| <b>Project:</b>                  | William Kay House, The University of Manchester |                                |
| <b>WML reference number:</b>     | 12023R-WML-XX-ZZ-RP-S-5001                      | 17 <sup>th</sup> February 2025 |

| <b>Survey Brief:</b>                  | Structural condition survey in advance of proposed refurbishment project                                                                                                                                                                                                                                                                                                                         |

Photo 14

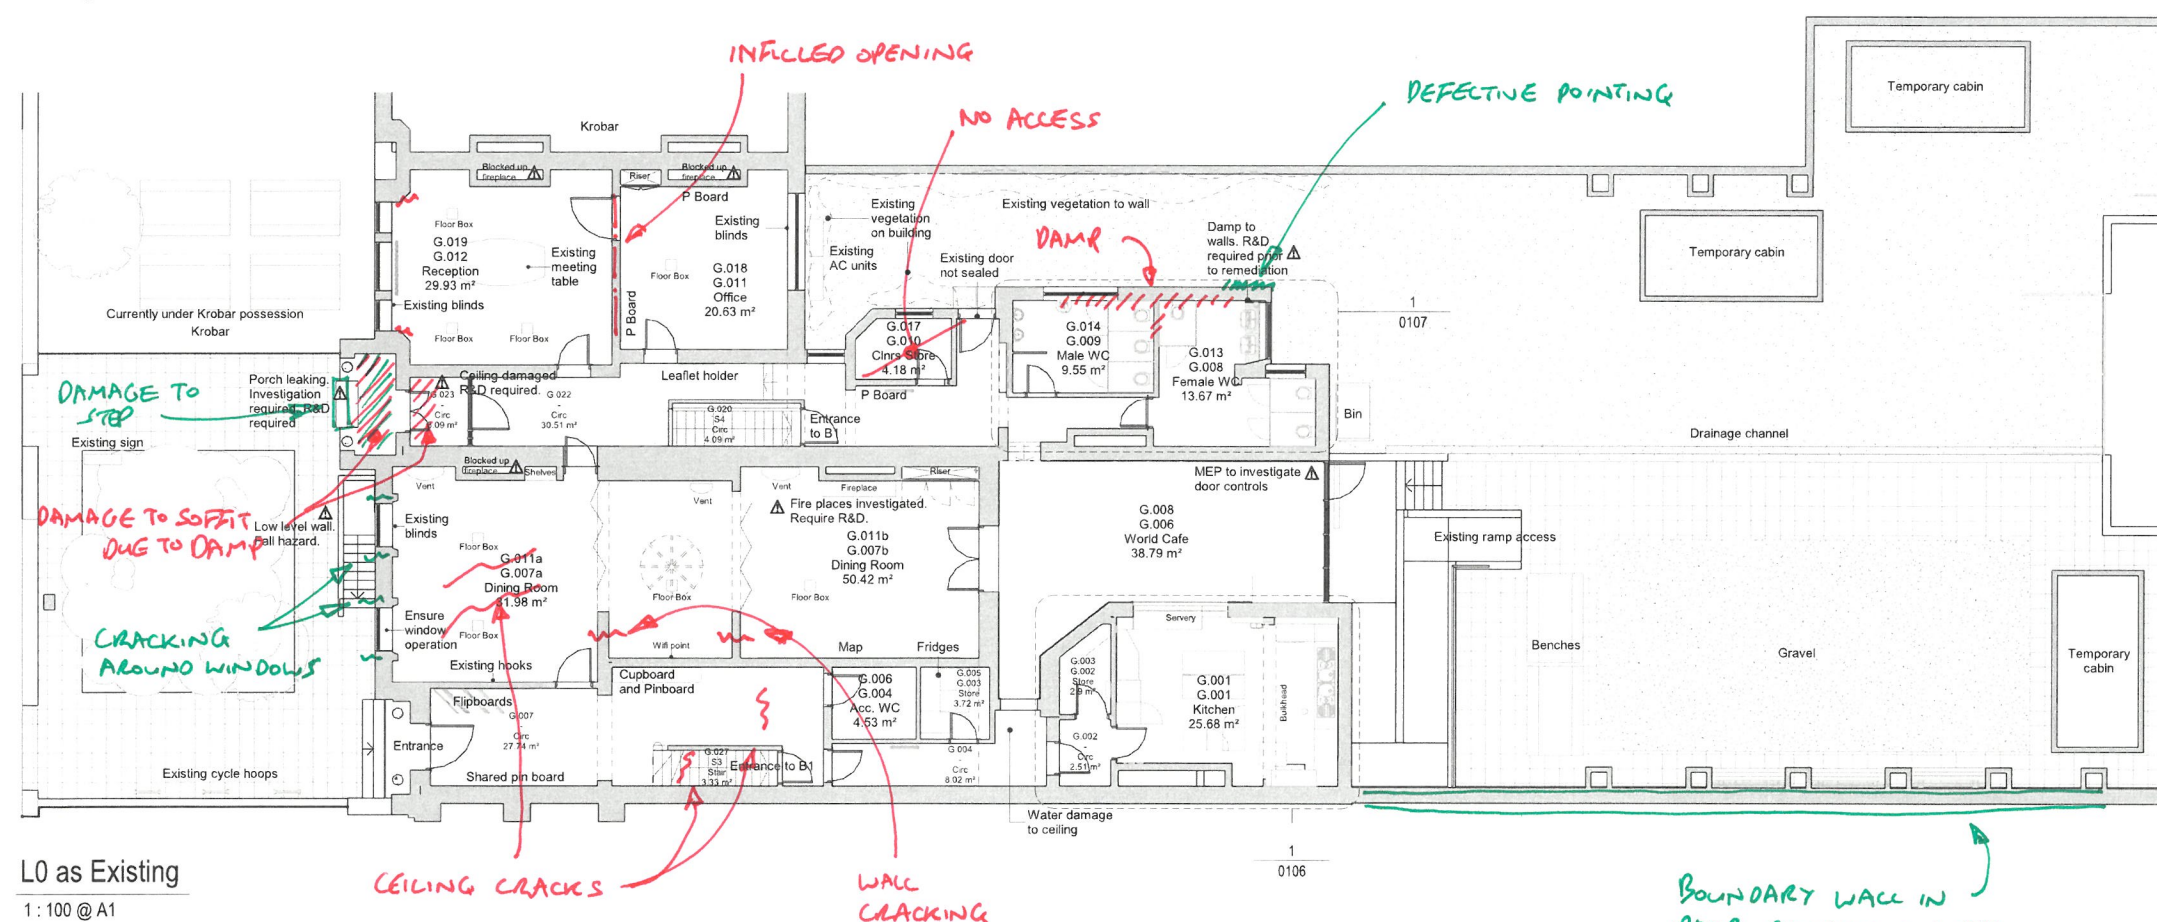
- It was noted that the main staircase is supported by a stainless-steel tension rod system, which is clearly a modern intervention. There is cracking to the walls and ceilings of the adjacent corridors which may be related to previous movement of the staircase (photo 14)

Photo 15

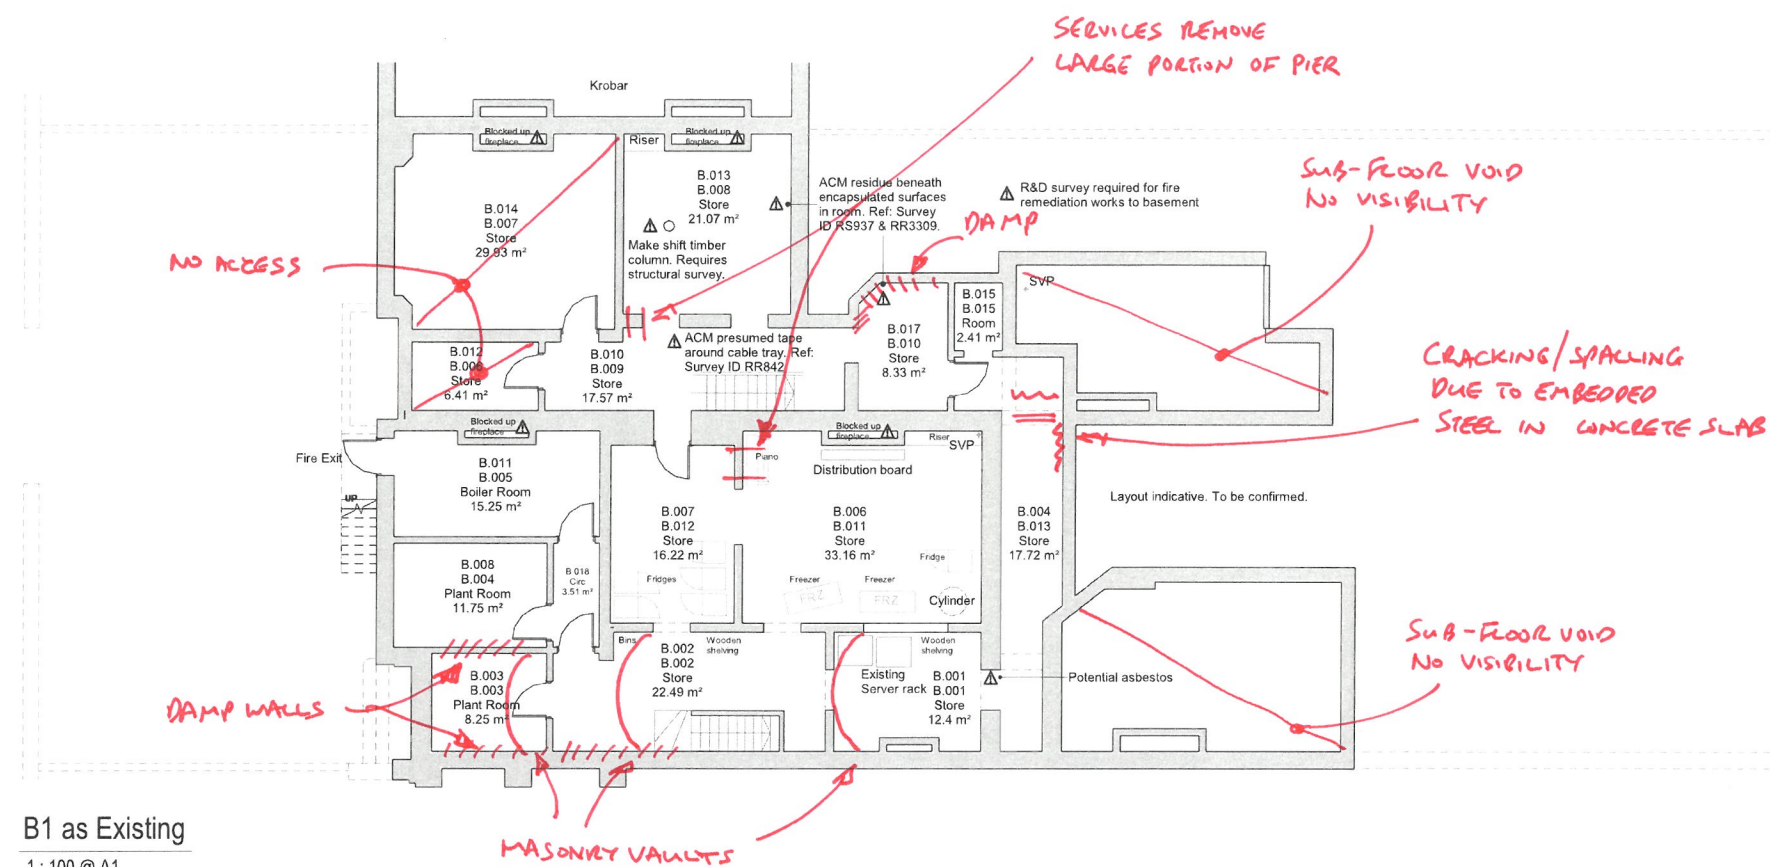
- Some areas of damp were noted to walls at ground floor and basement level.
- The floor over the north end of the basement corridor B.004/B.013 is a concrete filler joist slab and there is evidence of corrosion to the embedded steelwork (photo 15). There were also steel lintels in this area and cracked brickwork which suggests corrosion of embedded steelwork (photo 16).

- The area of concrete filler joist slab to the rear (over B.004/B013) should be hammer tested to remove any loose concrete, exposed steelwork should be cleaned and treated and the concrete reinstated using a specialist concrete repair mortar.

Photo 17

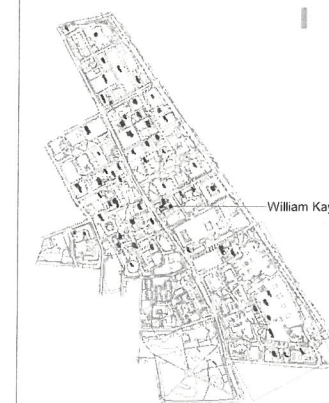
- A timber column has been installed in the basement room B.013/B.008. The column is formed from a pair of timbers bolted together and appears to be an engineered solution (photo 17). The purpose of the column is not clear as the location does not appear to align with any structure above.

- Current proposals for the basement do not require the timber post to be removed. The post appears to be in good condition and as such it is suggested that it should remain.

| Drawing Number<br>5668-HMA-WK-ZZ-DR-A-0101 |                    |                    | Revision<br>P01    |

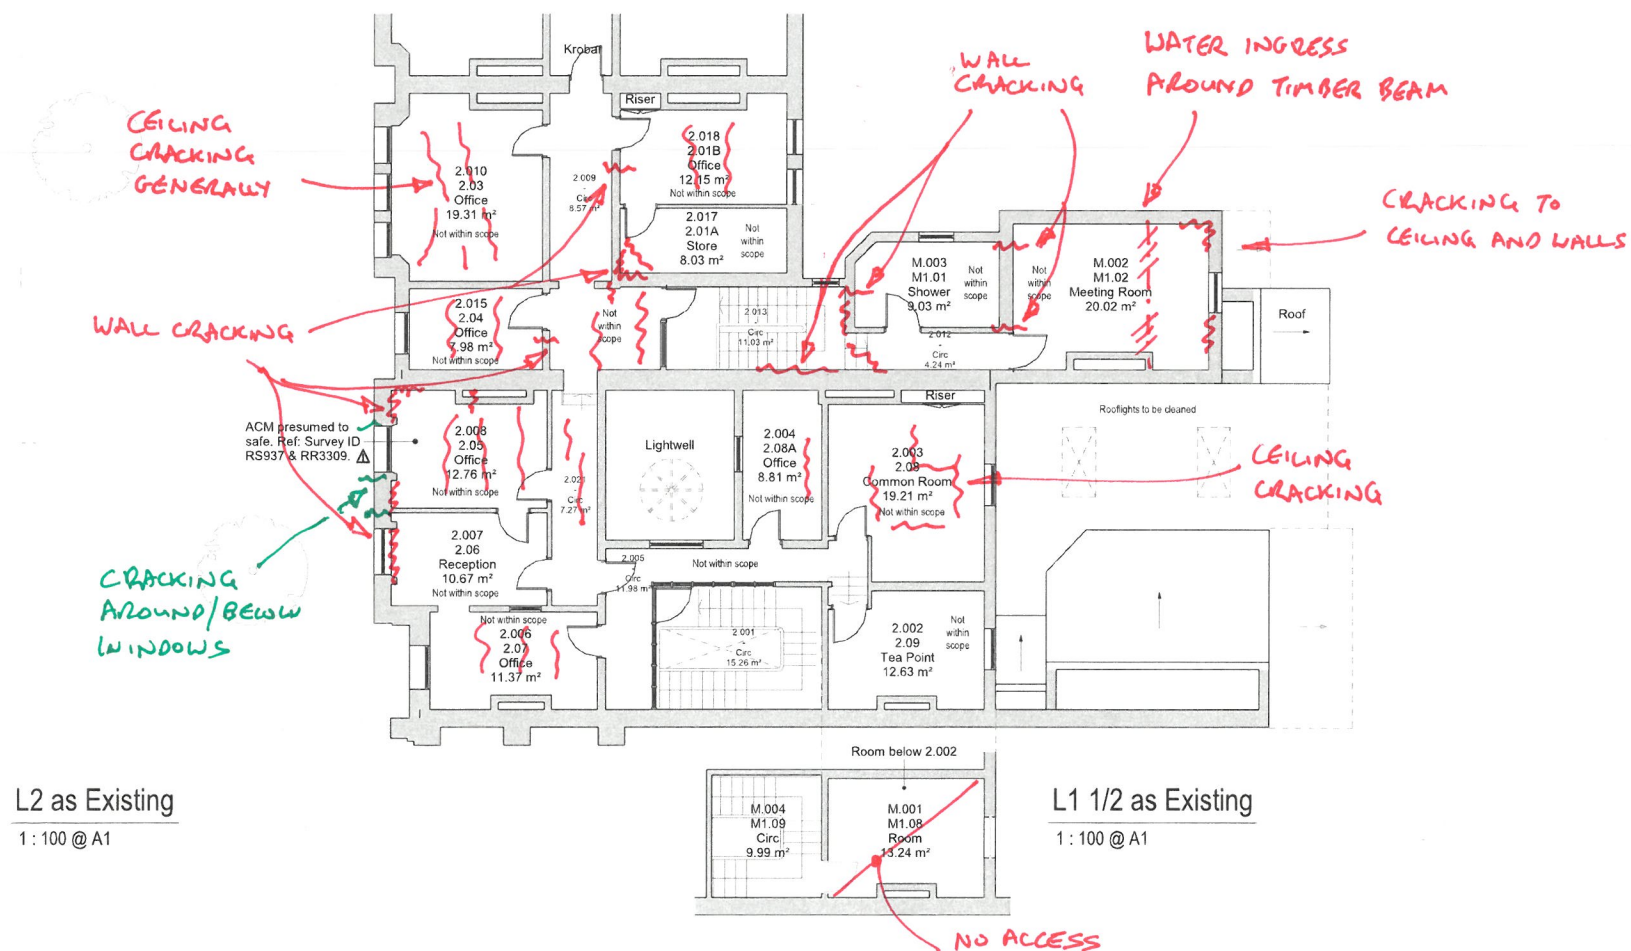
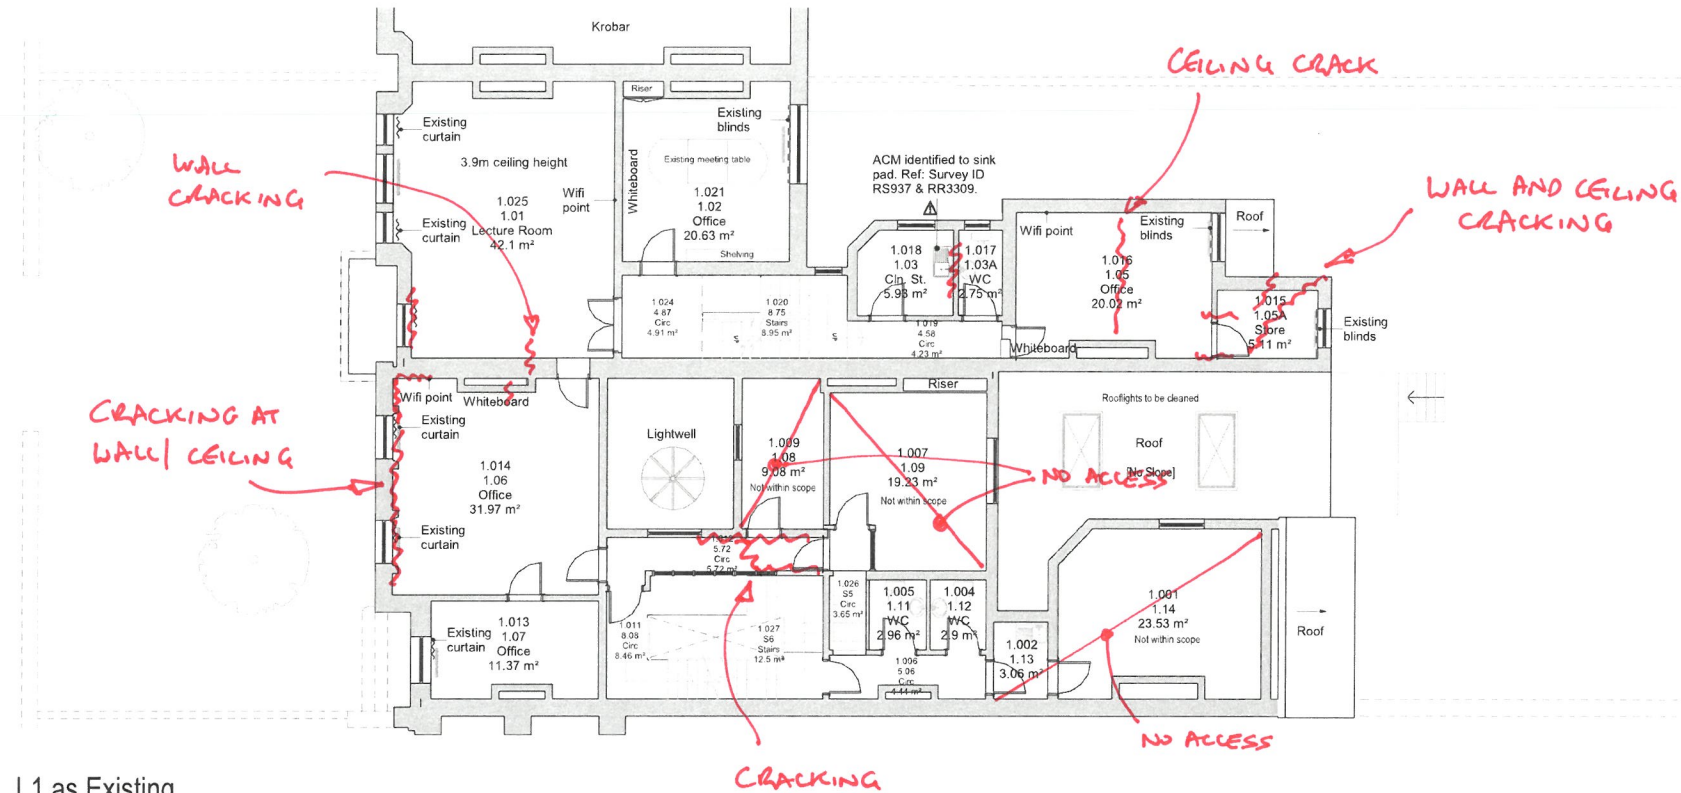
12023 R  
ASL SITE NOTES  
WML CONSULTING Ltd  
14/2/2025

| Drawing Number<br>5668-HMA-WK-ZZ-DR-A-0102 |                    |                    | Revision<br>P01    |

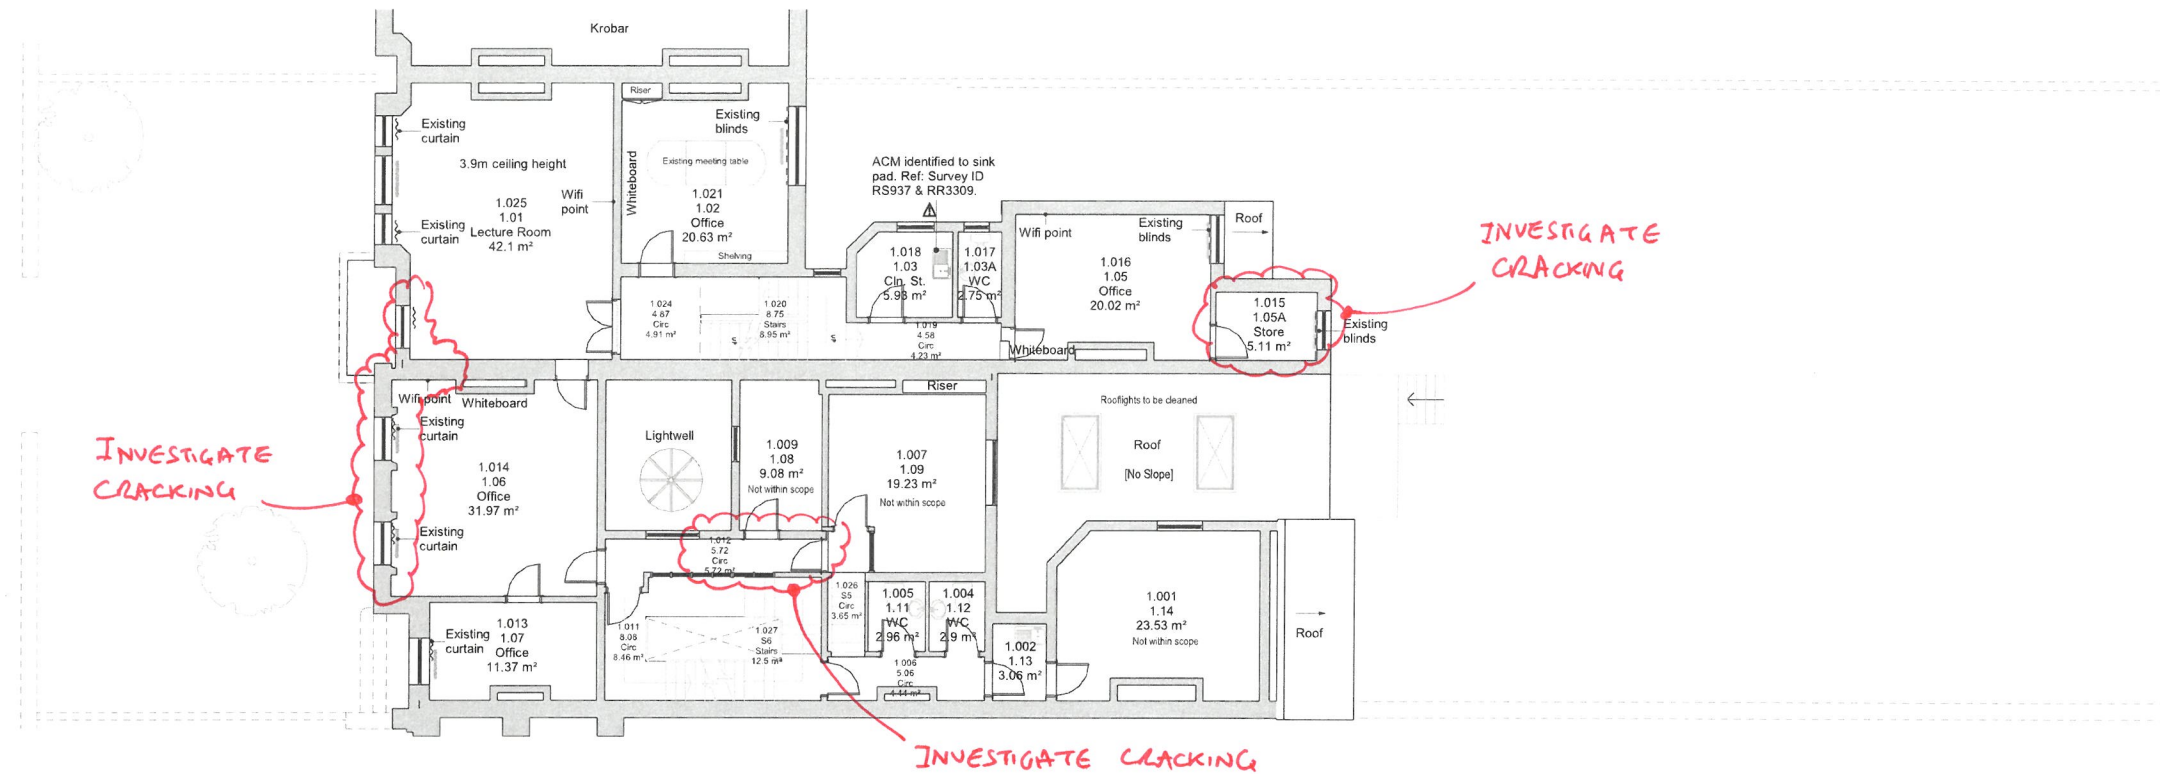
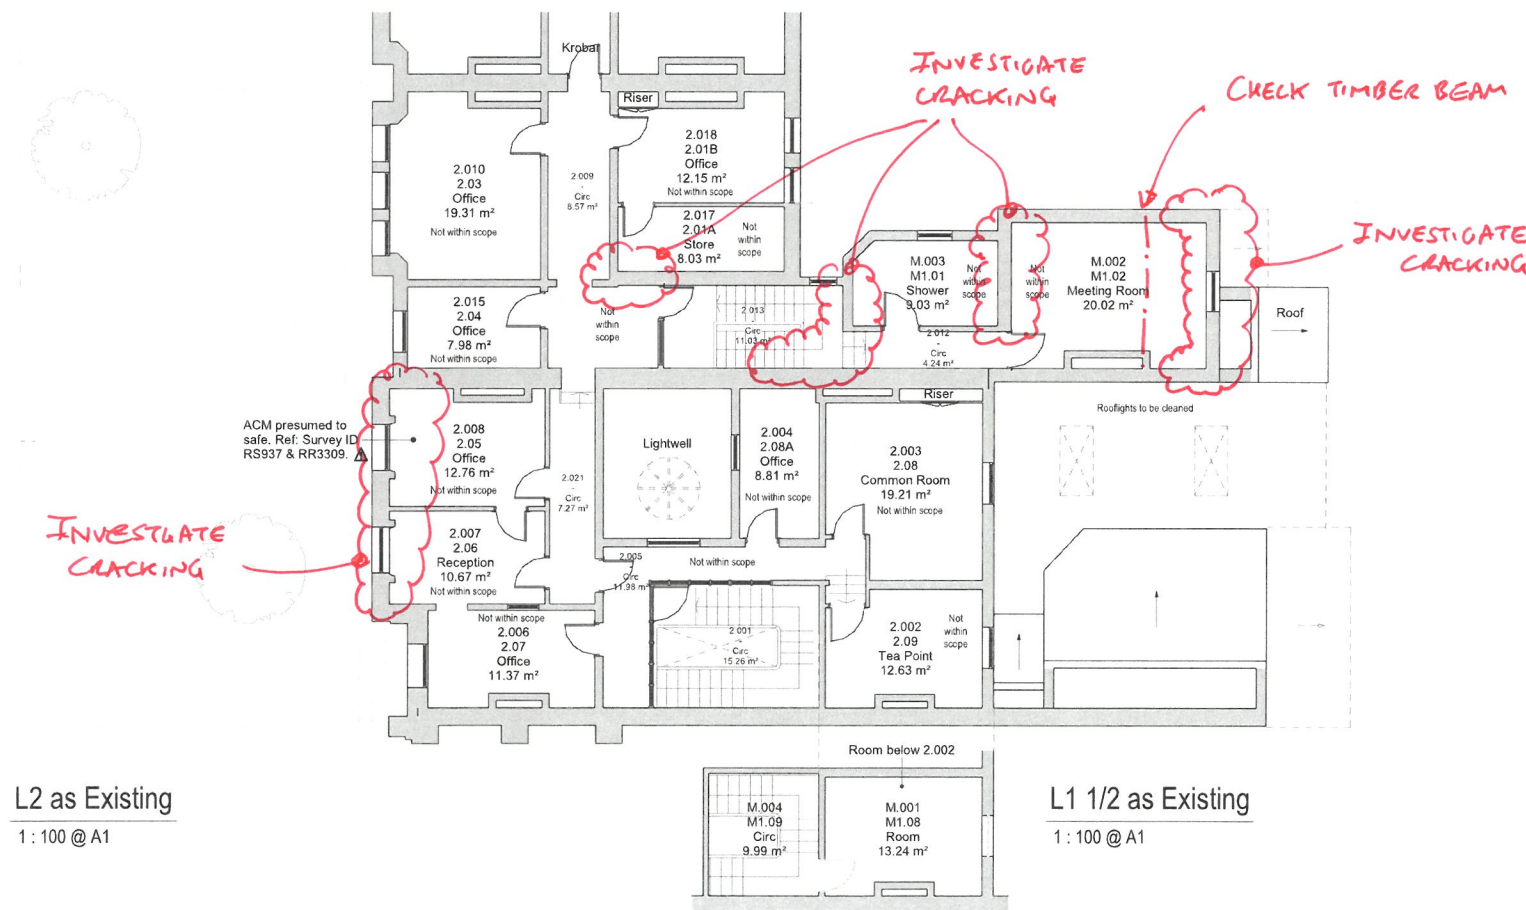
1/2023R  
ASL SITE NOTES  
WML CONSULTING LTD  
14/2/2025
